# UNITED STATES PATENT AND TRADEMARK OFFICE

APPLICATION NO.	FILING DATE	FIRST NAMED INVENTOR	ATTORNEY DOCKET NO.	CONFIRMATION NO.
10/516,725	12/01/2004	Johan Christiaan Halberstadt	NL02 0451 US	9943
65913	7590	09/26/2007		
NXP, B.V. NXP INTELLECTUAL PROPERTY DEPARTMENT M/S41-SJ 1109 MCKAY DRIVE SAN JOSE, CA 95131			EXAMINER TRAN, NGUYEN	
			ART UNIT 2838	PAPER NUMBER
			NOTIFICATION DATE 09/26/2007	DELIVERY MODE ELECTRONIC

<b>Office Action Summary</b>	<b>Application No.</b> 10/516,725	<b>Applicant(s)</b> HALBERSTADT ET AL.	
	<b>Examiner</b> Nguyen Tran	<b>Art Unit</b> 2838

## **DETAILED ACTION**

FIG. 4

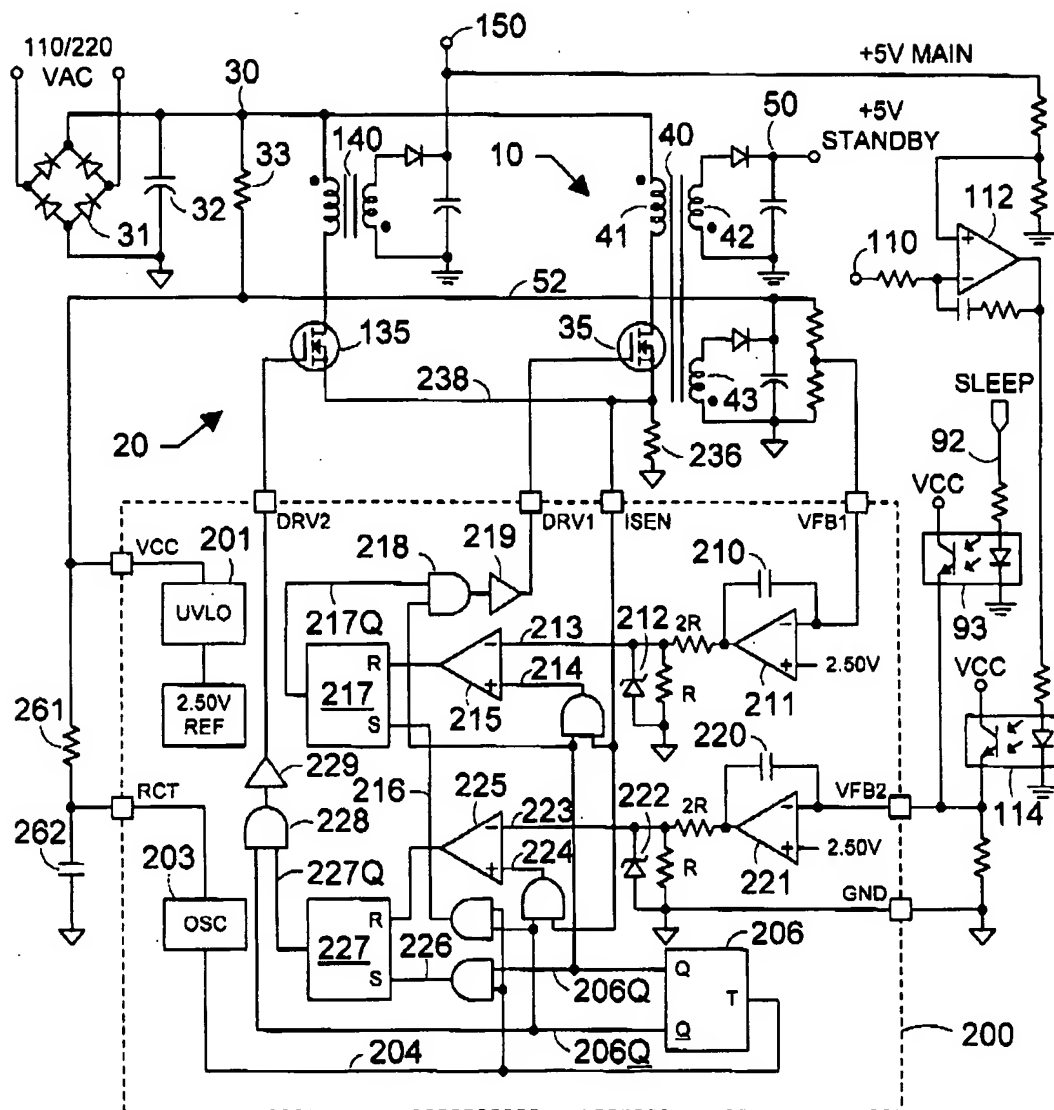
**Regarding claims 1-12:** for the purpose of examination the Examiner interpreted the claims as shown in figures 4 and 5. Therefor claims 1-12 are rejected under figures 4 and 5 see below.
